Notes to Plan reviewer:

I used the plan set attached in my review comments and snapshot them below for your easy reference on the issues I found.

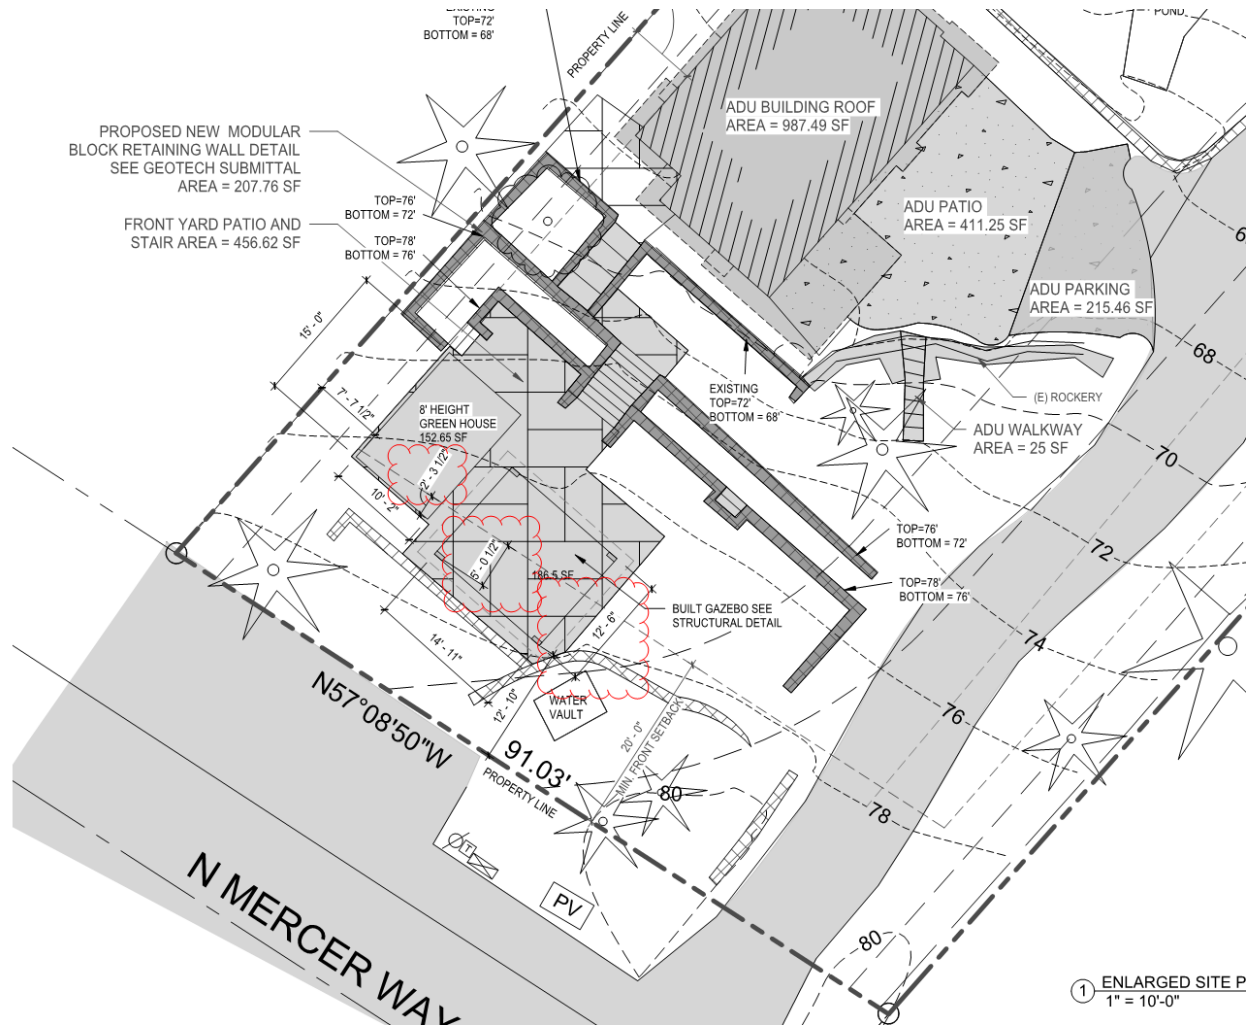
3-24-2025 my review comments - Site Plan – show both greenhouse and Gazebo intrude into the 20 ft property setback. See red circled above. However, in the later versions the Green house size seem shrunk and show not intruding anymore? Why?

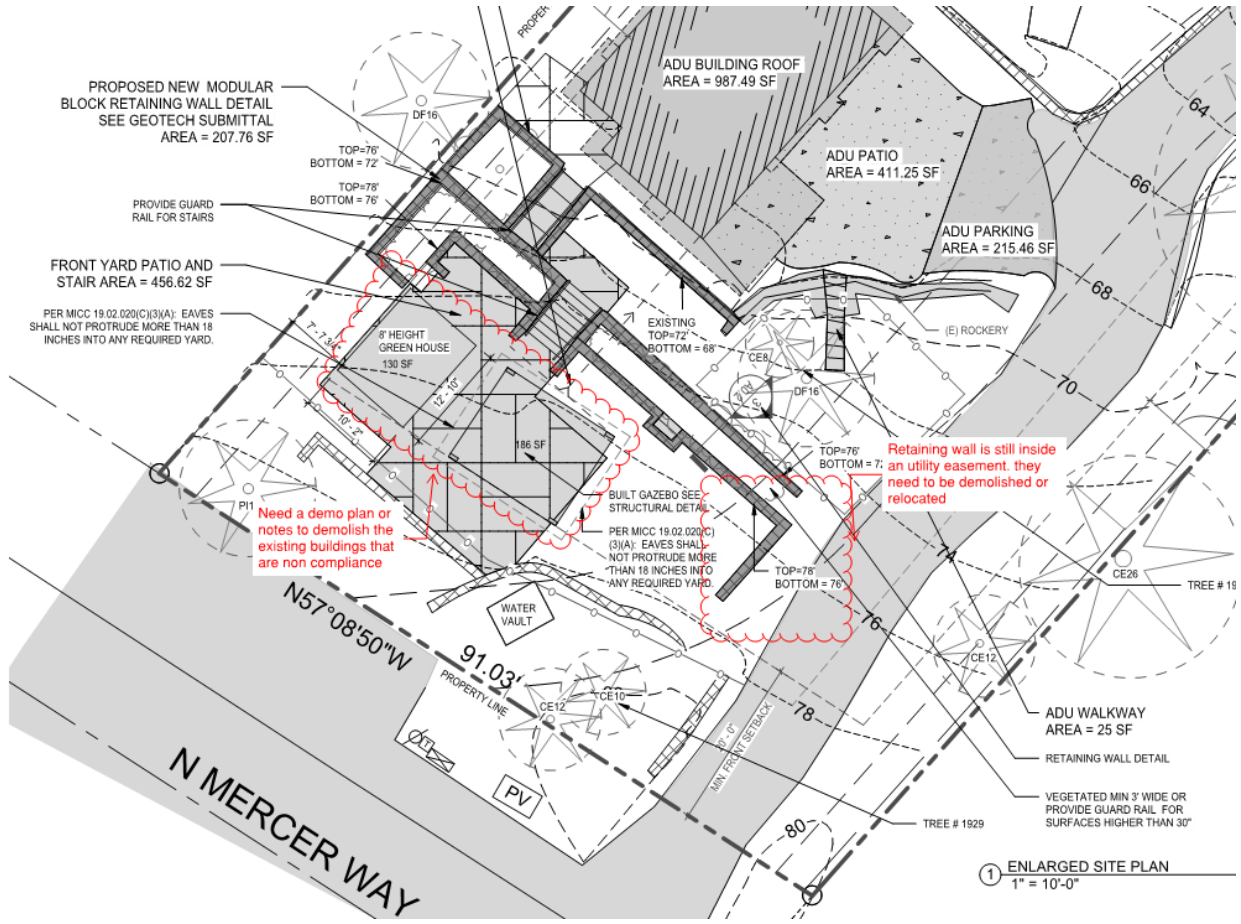
8-4-2025 Review comments - Site Plan. From the above plan, the Greenhouse seems stayed right outside of the 20 ft setback. It conflicts with the plan I received for my 3/24/2025 review comments. At that time, the permit plan shows the Greenhouse intrudes into 20 ft setback by 2'-3.5". (see the first page).

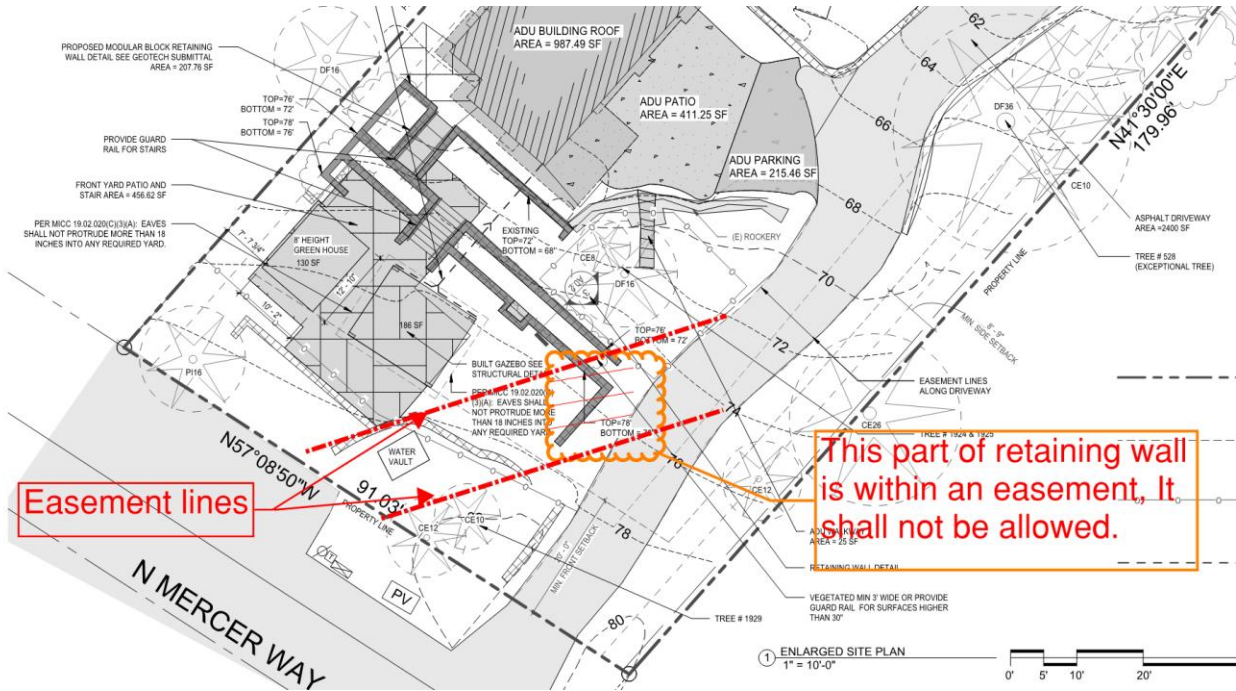
11-1-2025 Public appeal 8636 plan – they have the same problems as shown in the 8-4-2025 review comments (page 2 above);

And new issue - the dot lines showing the old driveway was deleted.

1. The old easement shown by dots lines should be added back to the plan.
2. The retaining walls still intrude into the easement. They should be removed.
